Study Group 15

Source: AT&T (Amy R. Reibman and Barry Haskell)

Title: Proposed Addition to H.245 for Jitter Control (in ATM Networks)

Purpose: Discussion and Proposal

Figure 1. Possible scenario for jitter control signalling.

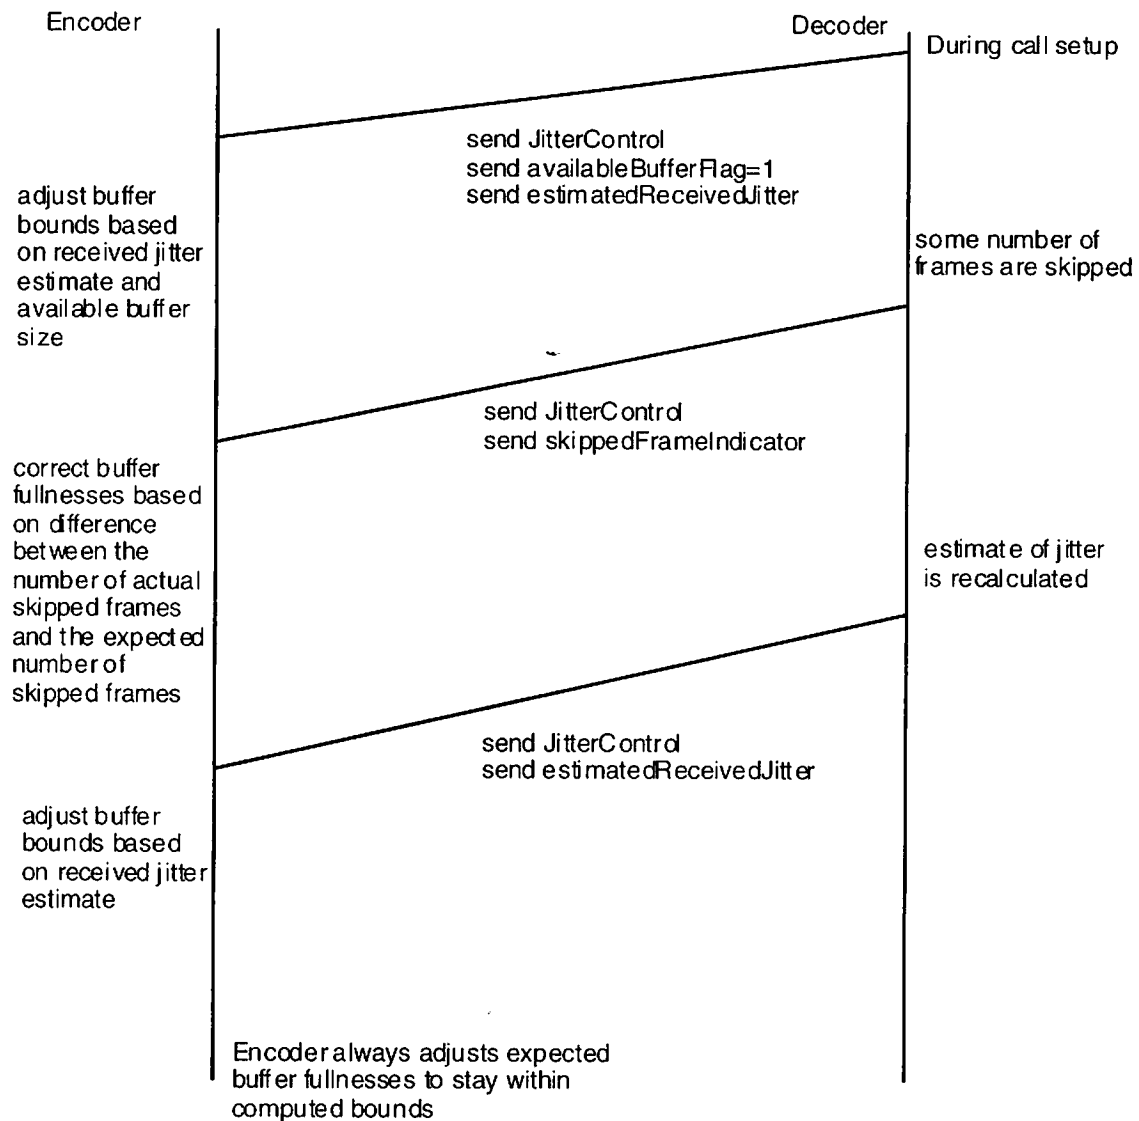
Figure 1 shows a possible signaling time-line for the encoder and decoder.
